Revision to a Request for Supply Arrangement - Révision à une demande pour un arrangement en matière d'approvisionnement

Title - Sujet Furniture for Work Spaces	
Solicitation No. - N° de l'invitation E60PQ-140003/C	Date 2018-05-04
Client Reference No. - N° de référence du client E60PQ-140003	Amendment No. - N° modif. 004
File No. - N° de dossier pq992.E60PQ-140003	CCC No./N° CCC - FMS No./N° VME
GETS Reference No. - N° de référence de SEAG PW-\$\$PQ-992-74154	
Date of Original Request for Supply Arrangement 2018-01-17 Date de demande pour un arrangement en matière d'app. originale	
Solicitation Closes - L'invitation prend fin at - à 02:00 PM on - le 2099-04-30	
Time Zone Fuseau horaire Eastern Daylight Saving Time EDT	
Address Enquiries to: - Adresser toutes questions à: Vlahos, Helen	Buyer Id - Id de l'acheteur pq992
Telephone No. - N° de téléphone (613) 220-8951 ()	FAX No. - N° de FAX () -
Delivery Required - Livraison exigée	
Destination - of Goods, Services, and Construction: Destination - des biens, services et construction:

This amendment 004 to E60PQ-140003/C is raised for the following purpose:

Q70- Item 1.6.2

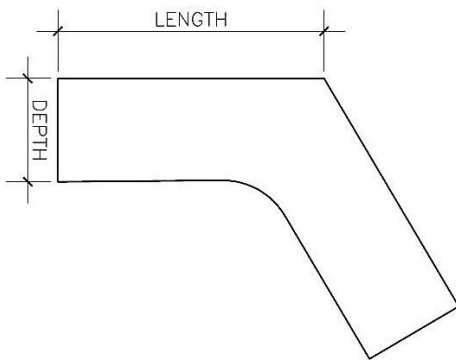
It is stated *Refer to image below:* is an image available?

The image was missing from solicitation

See below:

Q73- Item 1.6.42 – Transitional work surfaces

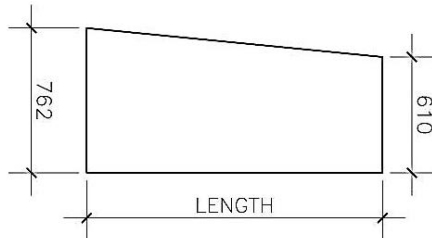
It is stated *Refer to image below*: is an image available?

Image was missing from solicitation

See below:
